**Economic Commission for Europe****Inland Transport Committee****World Forum for Harmonization of Vehicle Regulations****183rd session**

**1958 Agreement:****Consideration of draft amendments to existing****UN Regulations submitted by GRVA****Advance copy****Proposal for the 02 series of amendments to UN Regulation  
No. 152 (AEBS for M<sub>1</sub> and N<sub>1</sub>)****Submitted by the Working Party on Automated/Autonomous and  
Connected Vehicles\***

Annex 2, amend to read (addition of a letter "B" in the marking and its reference in the text):

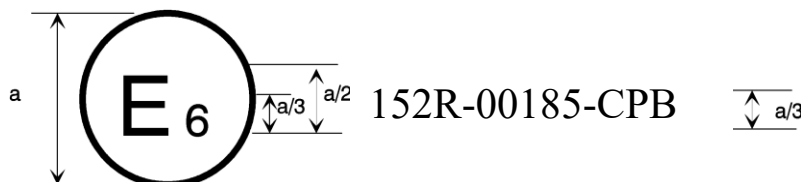
The above approval mark affixed to a vehicle shows that the vehicle type concerned has been approved in Belgium (E 6) with regard to the Advanced Emergency Braking Systems (AEBS) pursuant to Regulation No. 152 (marked with C for Car to Car, P for Car to Pedestrian, B for Car to Bicycle). The first two digits of the approval number indicate that the approval was granted in accordance with the requirements of Regulation No. 152 in its original form.”
